Body ATU
January 2018

Work specific to Cabriolet, A5/B9 Cabriolet

Work specific to Cabriolet A5/B9 Cabriolet

1.1) Visible imprint on CRCL trim

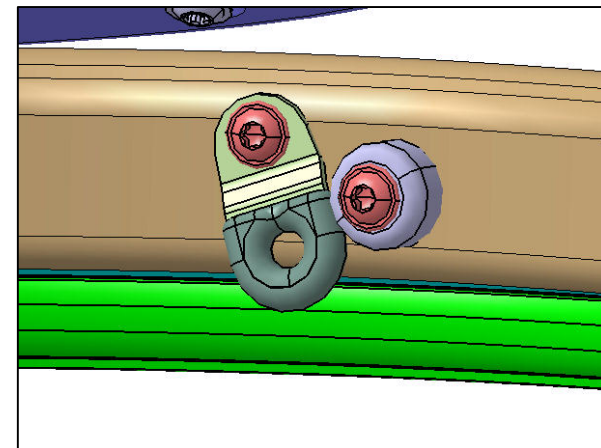
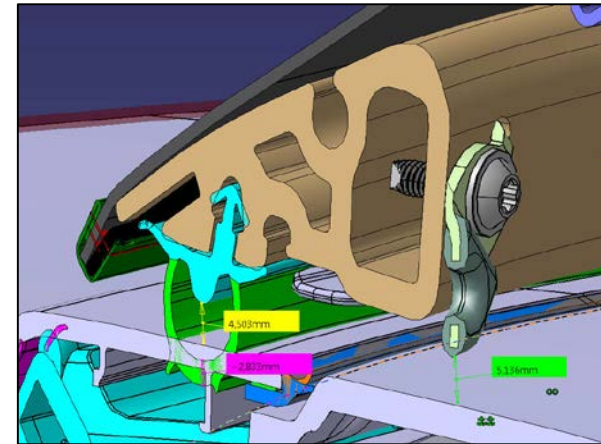
Concern: Imprint on CRCL trim.

- > Eyelet of cable guide can move freely and may, in the worst case, become positioned against fixed stop pin.
- > As a result, there is insufficient distance between edge of eyelet and surface of CRCL trim.
- > In this position, edge of eyelet makes an indentation (imprint) in CRCL trim.

1.1) Visible imprint on CRCL trim

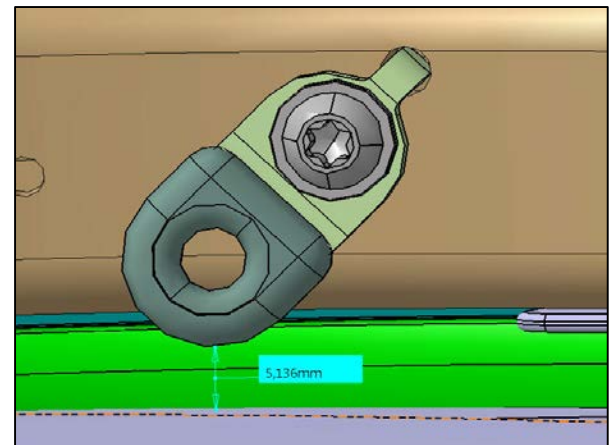
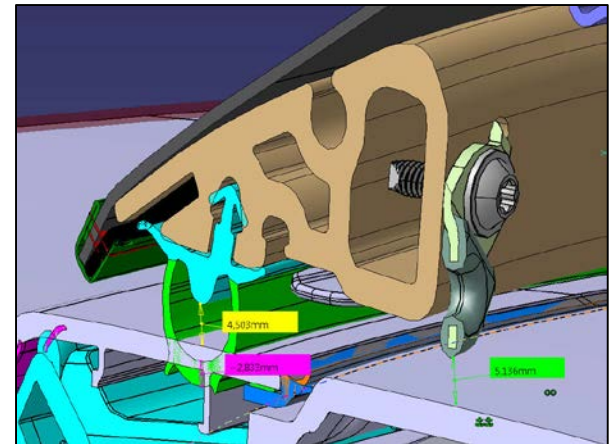
- > Eyelet of cable guide secured in place.
- > This prevents eyelet from moving (stop pin no longer fitted) and ensures adequate distance to CRCL trim.
 - > Gradual introduction starting week 20/2017

- > Sanding/filing off top edge of eyelet, approximately 2mm.
- > Check both sides (L/R) and adjust as necessary.
- > Damaged CRCL trim can be replaced: Part No.: 8W7 867 877 B

3.1) Convertible roof receiver in rear window frame - wiring damaged:

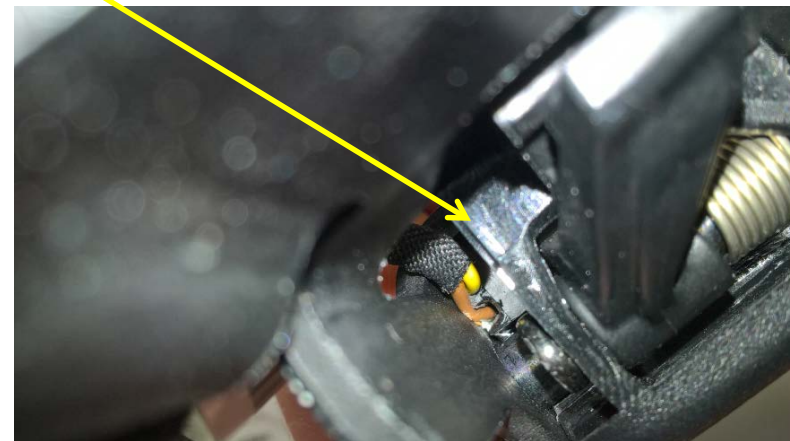
- Insulation on internal wiring for convertible roof receiver damaged at supplier when two halves of assembly housing are joined. Over time, this leads to a short to earth/short circuit caused by relative movement.

3.1) Convertible roof receiver in rear window frame – wiring damaged:

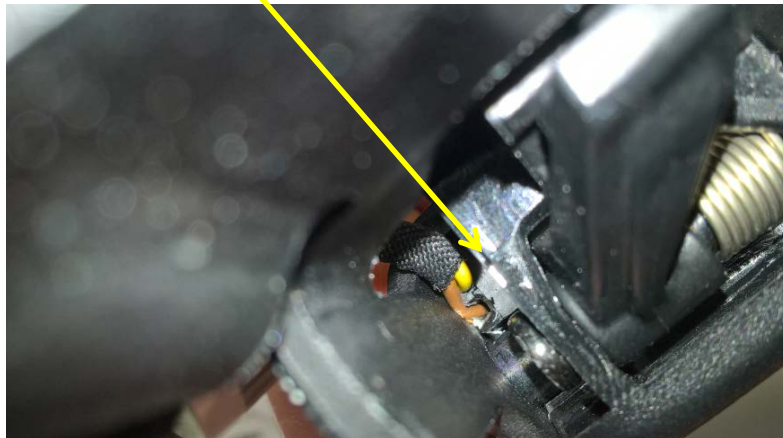
- › Affixed the wiring to main body with Cyberbond 2241 during attachment of assembly parts.

3.1) Convertible roof receiver in rear window frame – wiring damaged:

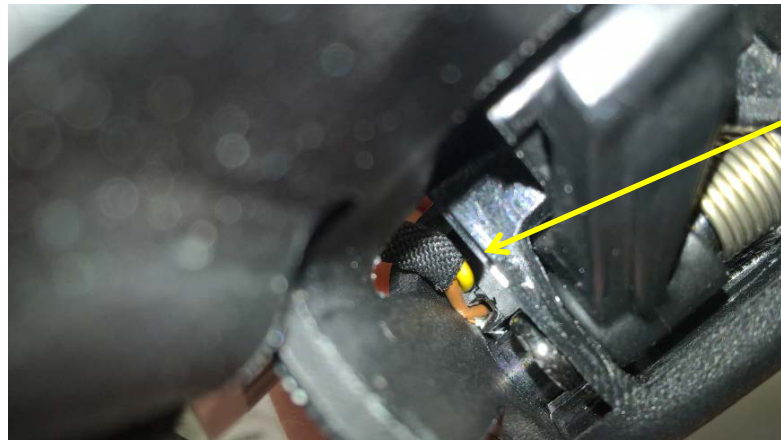
- › Installation of new part, carried out for vehicles already produced.

Rear lid lock sticks in first catch

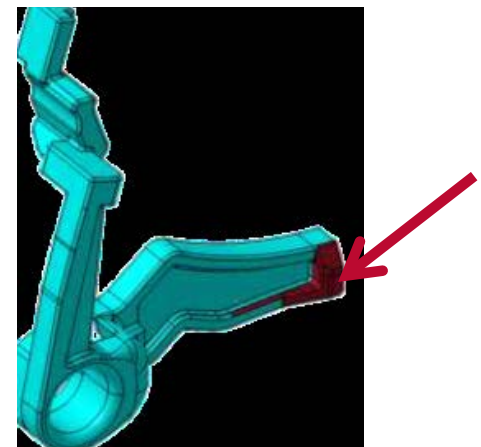
When opened, the power-operated rear lid remains stuck in the first catch of the rear lid lock. It can only be opened by pressing the button in the handle, on the remote control key or in the door trim. The problem usually occurs when opening the rear lid for the first time.

Due to insufficient coverage at the lowest tolerance for the snow load lever, the locking pawl in the lock is released too early.

- › When operated slowly, the lock sticks in the first catch (customer must unlock twice).

- › Modified component geometry of snow load lever.

- › Replace rear lid lock.
- › There are no DTC(s) stored in the diagnostic memory.

Rear lid only opens approximately 25 cm

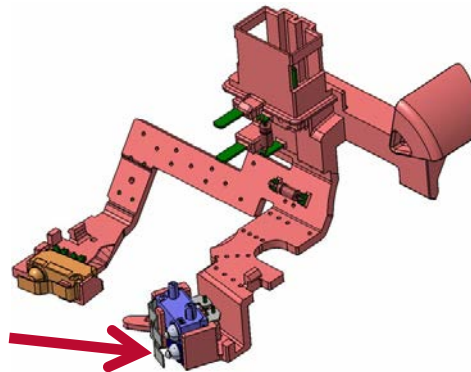
During opening, the power-operated rear lid stops moving after opening approximately 25 cm (sporadic fault). It is then generally only possible to completely open and close the rear lid by hand. This problem often depends on the temperature.

Bent switch lugs on the first catch microswitch can prevent it from switching, causing the first catch to remain closed although the rear lid lock is completely released.

- › The rear lid opens approximately 25 cm and then stops, as only from this opening height onwards does the rear lid control module require a signal from the first catch to continue powering the rear lid drives.

- › Modified packaging at sub-supplier and camera surveillance of switch lugs on production line starting in October 2017 and onwards.

Rear lid only opens approximately 25 cm

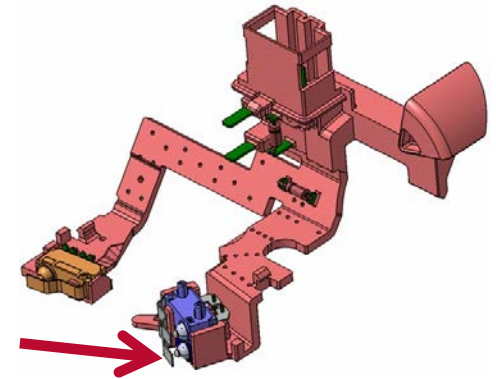
If the problem is constant, the rear lid lock status can be read out from the measured values in the rear lid control module, J605 (address word 006D).

- › Status of rear lid lock.
- › Rear lid lock in first catch.
- › Main catch open.
- › First catch closed.

- › There are no DTC(s) stored in the diagnostic memory.
- › Replace rear lid lock.

Rear lid is not pulled completely closed

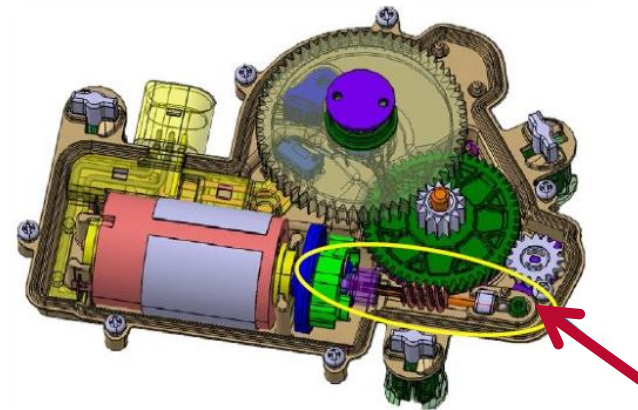
The power-operated rear lid does not close completely/closes only as far as the first catch in the rear lid lock. The rear lid must be pressed fully closed by hand. The problem occurs most often at cold ambient temperatures.

Too great a tolerance in the screw shaft drive can cause the power latching system drive to stick. The power latching system drive does not reach the end position after it is operated. End switch for power latching system drive is not operated.

- The rear lid control module creates the DTC B113E29 “Power latch - implausible signal - static” in the diagnostic memory.
- The rear lid control module cuts off current to the power latching system drive until this DTC is at least passive/sporadic again.

- Additional component check at -4° F screw shaft sorting starting in December 2016 onwards.

Rear lid is not pulled completely closed

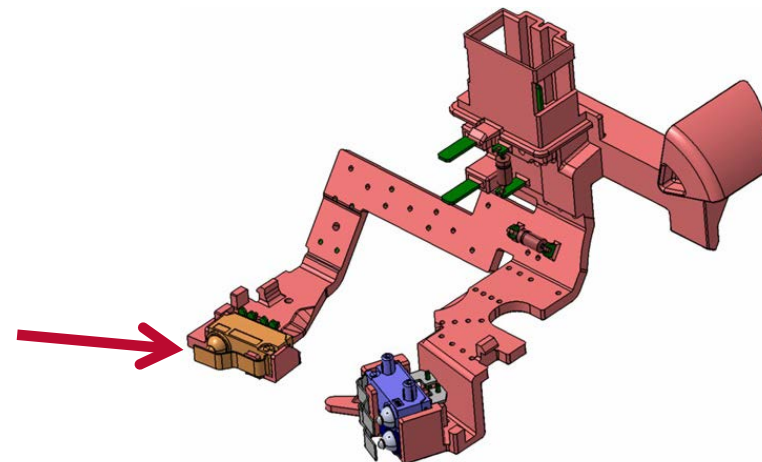
A bent switch lug on the main catch microswitch can cause the microswitch to switch prematurely even though the rear lid lock is only closed as far as the first catch.

- The rear lid control module registers that both microswitches already indicate a closed position.
- The rear lid control module does not send current to the power latching system motor, as the control module registers from the microswitch signals that the rear lid lock is already closed (even though the rear lid lock is physically only in the first catch).

- Modified packaging at sub-supplier and camera surveillance of switch lugs on production line starting in October 2017 onwards.

- Replace rear lid lock.
- There are no DTC(s) stored in the diagnostic memory.

Rear lid is not pulled completely closed

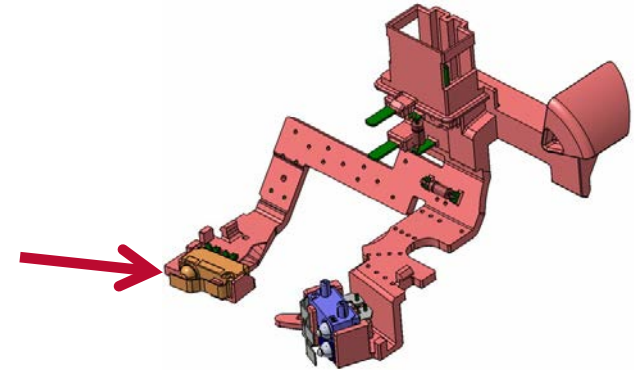
If the problem occurs, the rear lid lock status can be read out from the measured values in the rear lid control module, J605 (address word 006D).

- › Status of rear lid lock.
- › Rear lid lock closed.
- › Main catch closed.
- › First catch closed.

- › There are no DTC(s) stored in the diagnostic memory.
- › Replace rear lid lock.

Rear lid does not open all the way

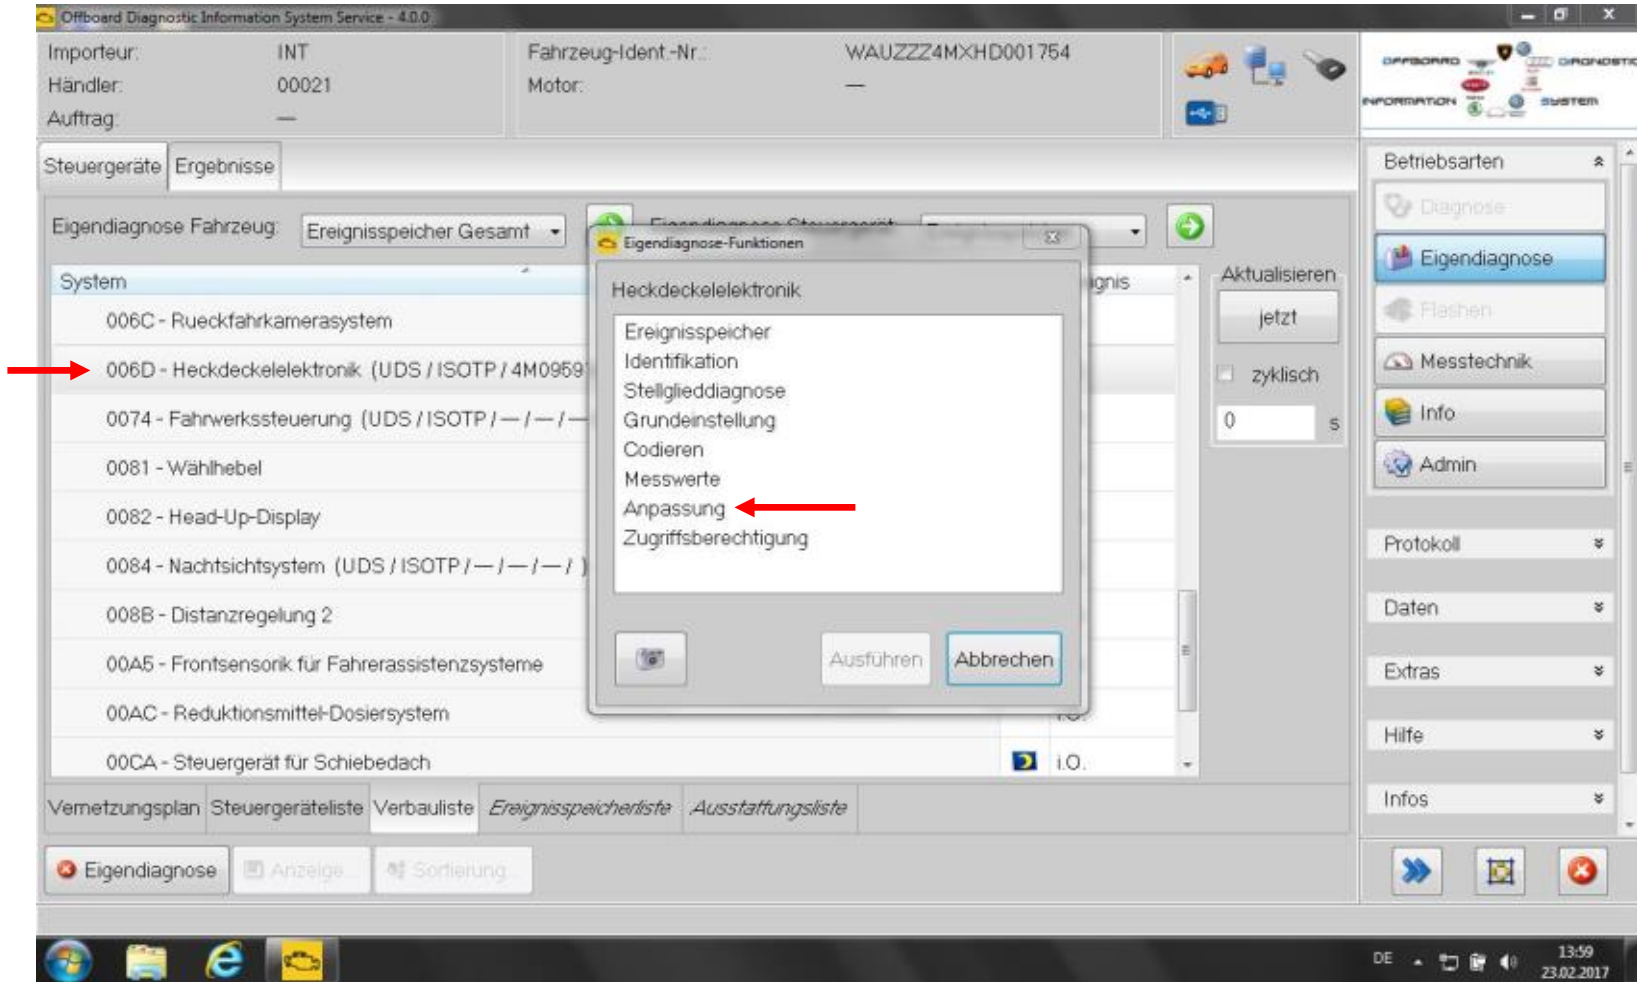
- › The instructions below describe the procedure for permanently setting the rear lid to open to the maximum power-operated position after reprogramming.
First, perform a basic setting for the rear lid control module, J605 (address word 006D).
- › Please carry out all steps as described in the test program in the rear lid control module, J605 (address word 006D) under “Basic setting - adapt opening angle of tailgate”.
- › Then change the value for the upper lock-in range to 150, as described on the following slides.
- › Changing this value ensures that, after reprogramming, the rear lid opens to the maximum power-operated position when it is programmed to open all the way.

After this measure is carried out, the maximum power-operated position is only set after the rear lid is opened 2 or 3 times.

TT (3rd generation): Noises from front seats – e.g. lumbar support

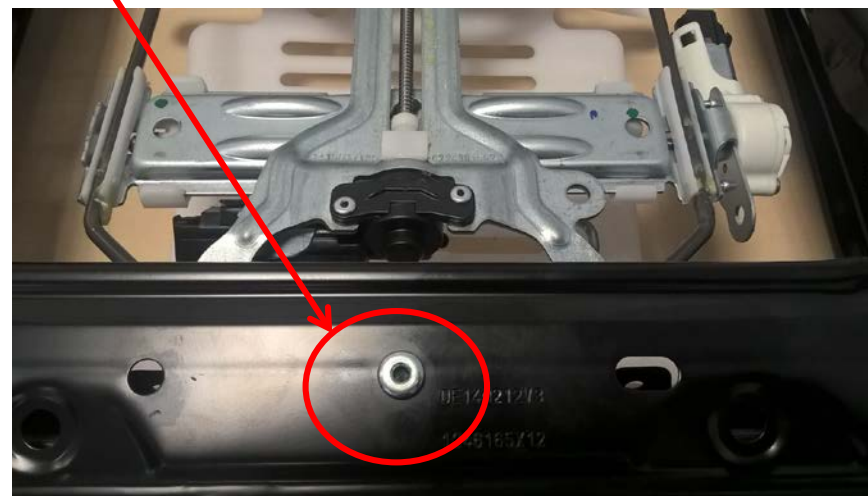
If the noises are coming from the area of the outer backrest frame, this may be caused by the connection between the lumbar support and the outer backrest frame.

- › Play between rivet for lumbar support and lower outer backrest frame.

- › Drill out old rivet and fit a larger rivet.

TT (3rd generation): Noises from front seats – e.g. seat frame

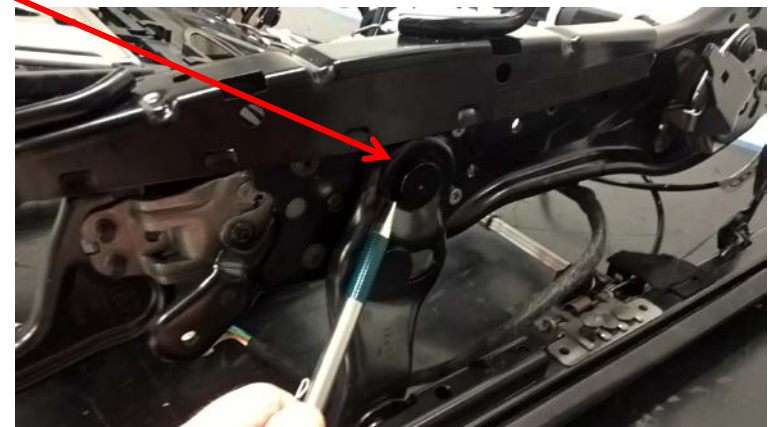
If the noises are coming from the area of the seat frame, this may also be caused by the connection to the hinged lever (top).

- › Play between connection for hinged lever (top) and seat pan.

- › Please try to eliminate the noise by varying the height of the seat.
- › If this is not successful, the seat frame can be replaced.

MLB: Noises from seat depth adjuster

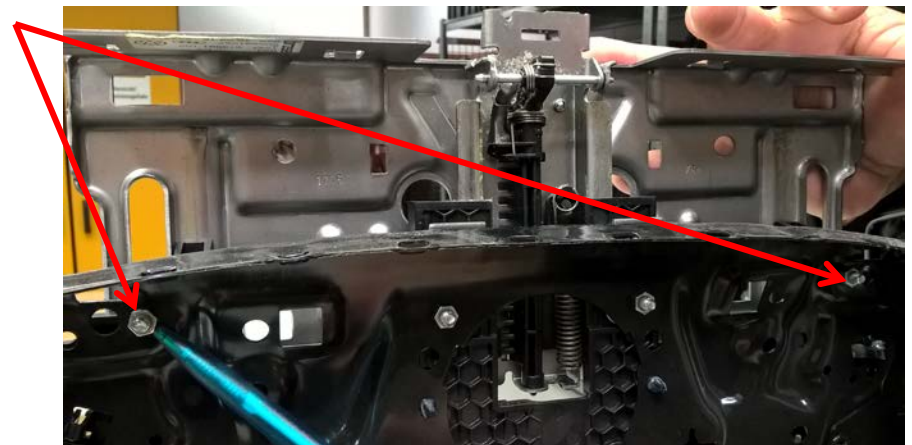
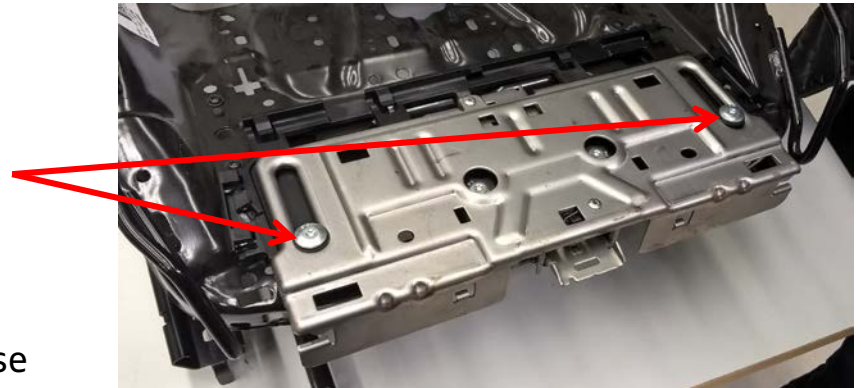
If the noises are coming from the area of the seat depth adjuster, this may also be caused by the connection between the seat depth adjustment unit and the seat frame.

- › Play between bolted connection for seat depth adjustment unit and seat frame.

- › Fit self-locking nuts instead of nuts and increase tightening torque to 7 Nm.
